Subj: ALAMEDA POINT OU-1 AND OU-2 DATA GAP SAMPLING ADDENDUM C

ADDENDUM C  
FINAL FIELD SAMPLING PLAN  
SUPPLEMENTAL REMEDIAL INVESTIGATION  
DATA GAP SAMPLING FOR  
OPERABLE UNITS 1 AND 2  
Contract Task Order 00385

ALAMEDA POINT  
ALAMEDA, CALIFORNIA

**Addendum C to Final Field Sampling Plan  
Supplemental Remedial Investigation Data Gap Sampling  
for Operable Units 1 and 2, Alameda Point, Alameda, California  
Clean II Contract No. N62474-94-D-7609  
Contract Task Order (CTO) No. 385**

**FIGURE 1**  
**MONITORING WELL**  
**SAMPLING LOCATIONS**  
**USTs 584-1 AND 584-2**  
 ALAMEDA POINT  
 ALAMEDA, CALIFORNIA  
 SEPTEMBER 5, 2001

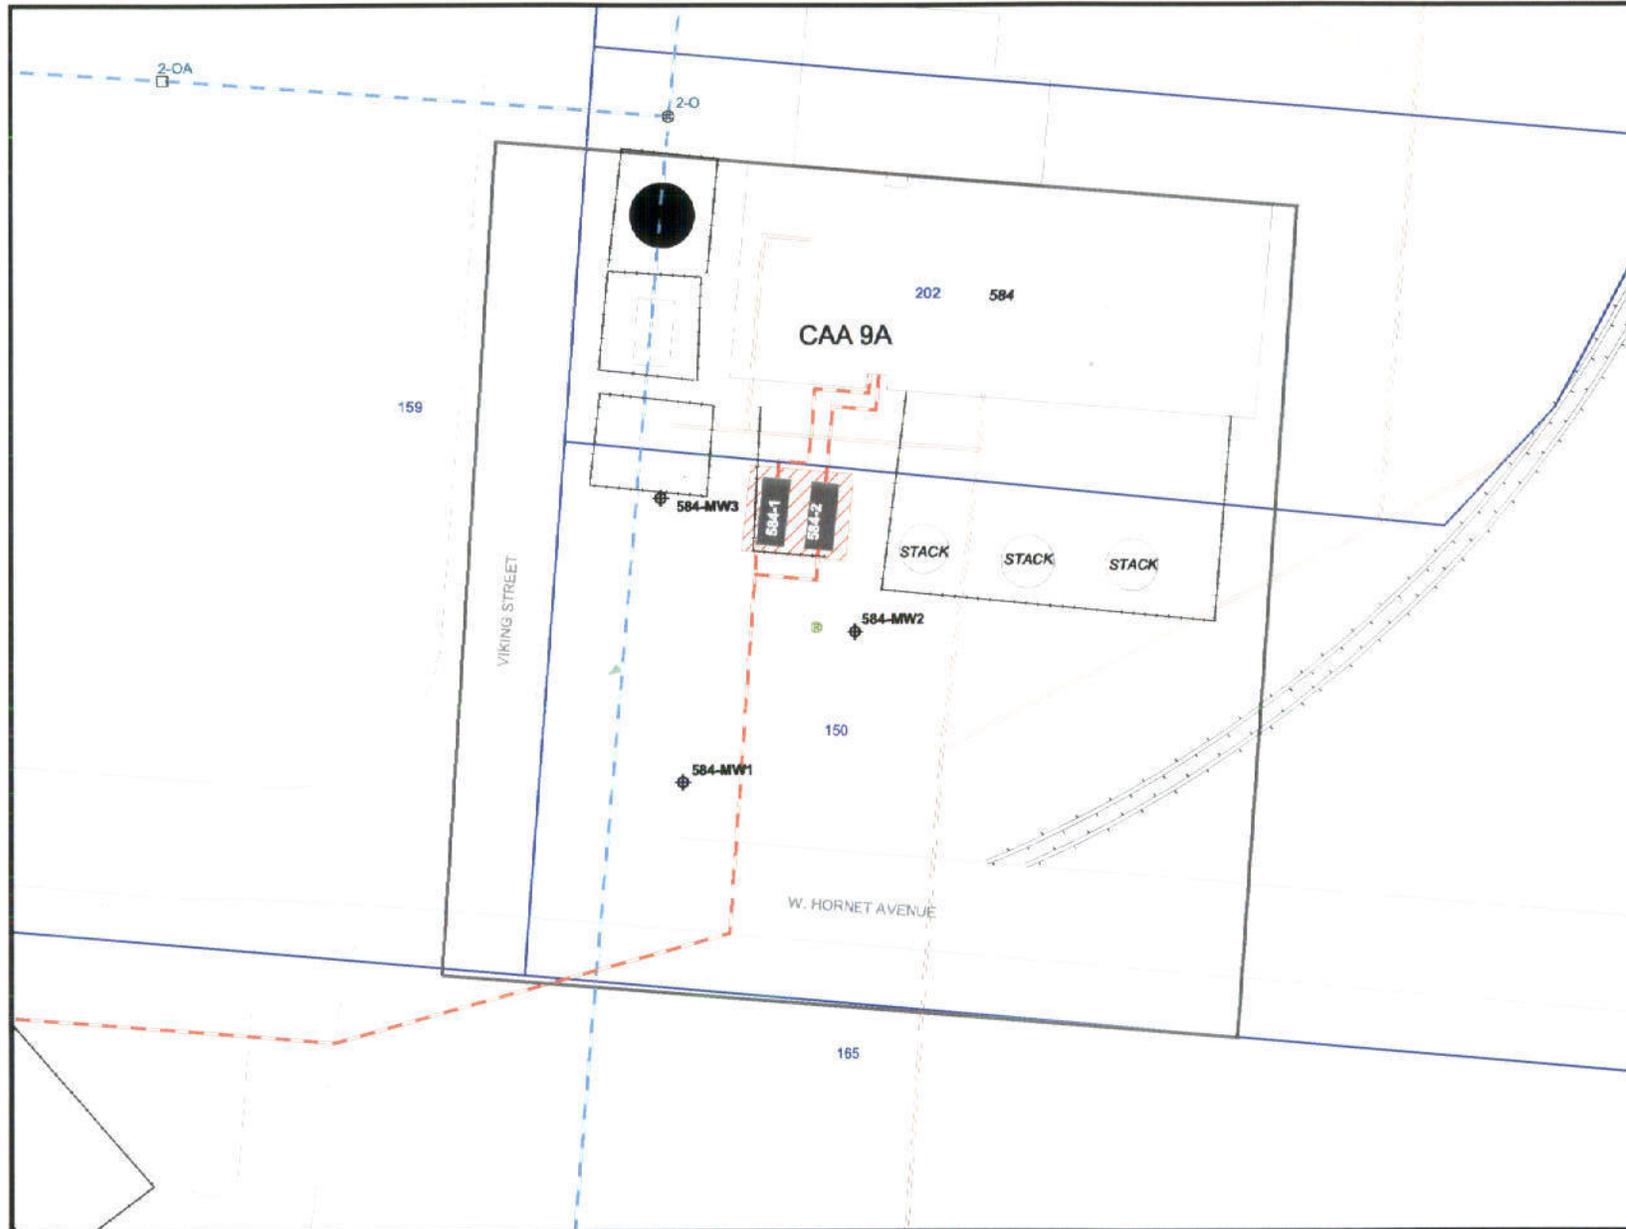
Additional samples will be collected from three monitoring wells located at CAA 9A as shown on Figure 1; such sampling will follow the data quality objectives previously identified in the FSP for groundwater sampling. The quality assurance project plan (QAPP) is not affected by this proposal. All other aspects of the FSP remain unchanged. Sampling of the three monitoring wells (584-MW1, 584-MW2, 584-MW3) at CAA 9A will be conducted to monitor the current total petroleum hydrocarbons (TPH) plume and evaluate whether the groundwater poses a risk to human health and the environment. The following sections of this addendum present further details concerning the additional data gaps at CAA 9A and the objectives of the proposed additional sampling to be conducted under Addendum C.

Three monitoring wells, which at one time contained concentrations of TPH greater than the PRC, are located downgradient of the TPH source (former diesel underground storage tanks [UST] 584-1 and 584-2). One of the monitoring wells (584-MW3) is located near the storm drain. The trend based on the last three sampling events does show that total TPH is decreasing; however, these monitoring wells were not sampled frequently enough to confirm that the TPH concentrations within the plume are no longer a threat to the storm drain seasonally. Therefore, Tetra Tech is proposing additional sampling of these three wells for collection of current TPH and TPH-associated compounds data to confirm the apparent trend of decreasing TPH concentrations and to provide analytical data collected within the same season (during similar groundwater elevations as the Fall 1998 sampling event). The analytical results from these additional samples will be used to support the recommendation of no further action and closure of the CAA and associated USTs.
